Access Compliance Report Public Rights-of-Way (RR Crossings)

| Intersection ID: 5600 | Main Street: N_TRYON_ST | Location: N/A |
| ADA ID: 63298004E671 | Overall Compliance: No | Severity Score: 0.0 |

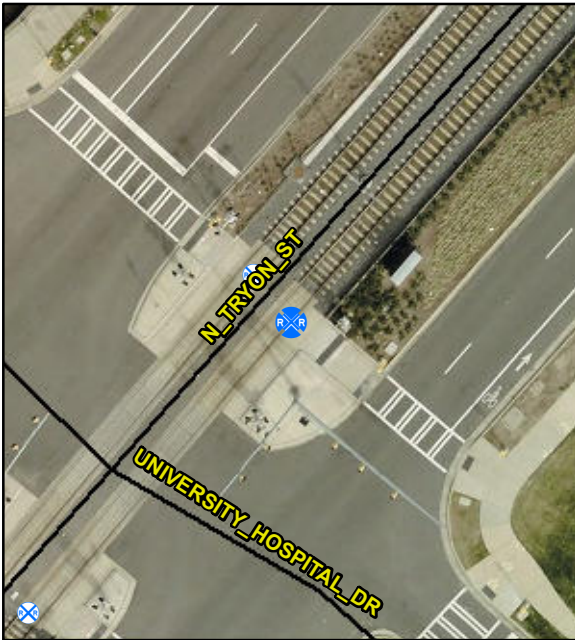
| Compliance | Description | Data |
|------------|---------------------|-----------|
| No | DWS Provided? | No |
| No | Flangeway Gap (in) | 3.0 |

**Install Detectable Warning System.
Remove & Replace Walking Surface
Adjacent to Rail.**
